Northern States Power Company
Prairie Island Nuclear Generating Plant
1717 Wakonade Dr. East
Welch, Minnesota 55089

PRAIRIE ISLAND NUCLEAR GENERATING PLANT
Docket Nos. 50-282 License Nos. DPR-42
50-306 DPR-60

Response to the August 30, 1995 Request for Additional
Information Regarding Generic Letter 92-08, "Thermo-Lag 330-1 Fire Barriers"
(TAC Nos. M85592 and M85593)

Northern States Power Co.
Prairie Island Nuclear Generating Plant
Response to the August 30, 1995 Request for Additional Information

ASTM E119.88 STANDARD CURVE FTC FURNACE TEMPERATURE

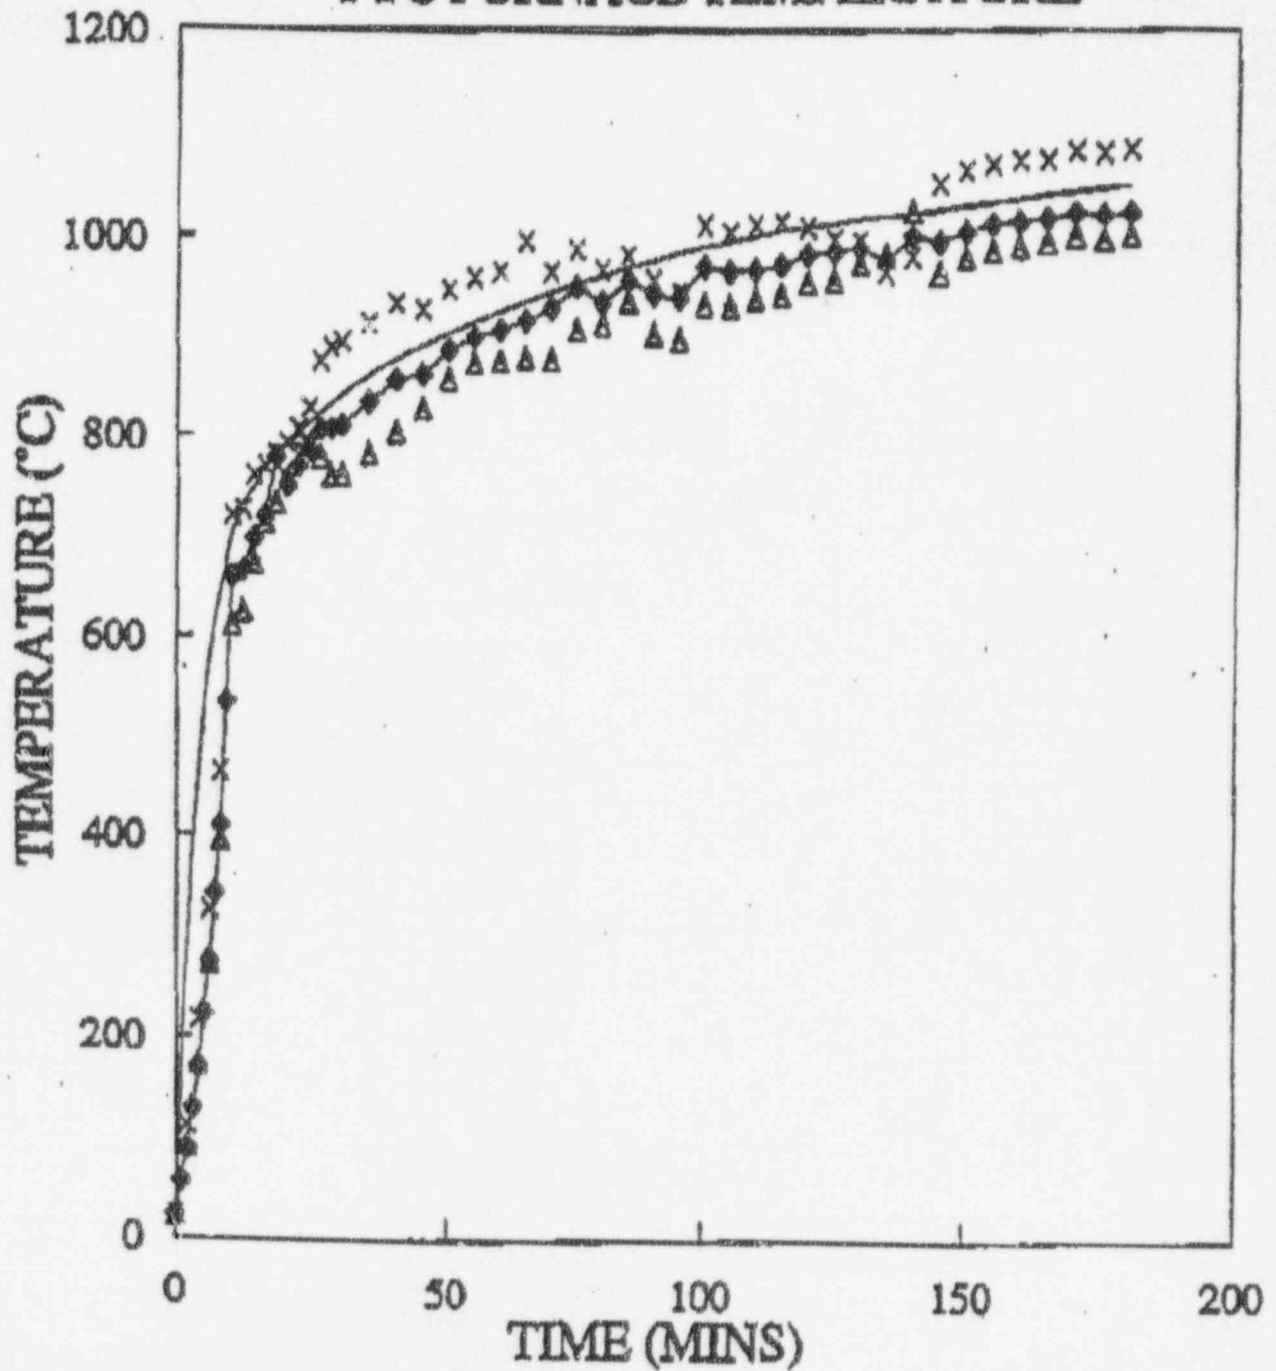
NRC QUESTION #2:

Section 4.2 of the test report states that ASTM [American Society for Testing and Materials] thermocouples provided by Underwriters Laboratories were used for reference, and positioned next to the controlling thermocouples. Please provide the thermocouple temperature data, and a comparison of the temperature data recorded by both the ASTM thermocouples and the controlling thermocouples related to the ASTM E-119 standard time temperature curve.

All the thermocouple temperature data, including the ASTM and the British thermocouples, is located in Appendix D of Fire Test Report FTCT/94/0060. The data for the British Standard thermocouples is on Pages 32 to 47 of the report and are listed under channels 145 to 152. The data for the ASTM (UL) thermocouples is on Pages 48 to 63 of the report under channels 93 to 100. The attached graph shows the average furnace temperature derived from the ASTM thermocouples. The graph also shows the minimum and maximum temperature readings from the ASTM thermocouples (the maximum and minimum temperature readings were not always the same thermocouple, at different time periods different thermocouples produced the maximum or the minimum).

The temperatures recorded by the British Standard controlling thermocouples were so close to the ASTM E119-88 Standard curve that only a single line is shown. The temperature data is shown on Page 25 of the report
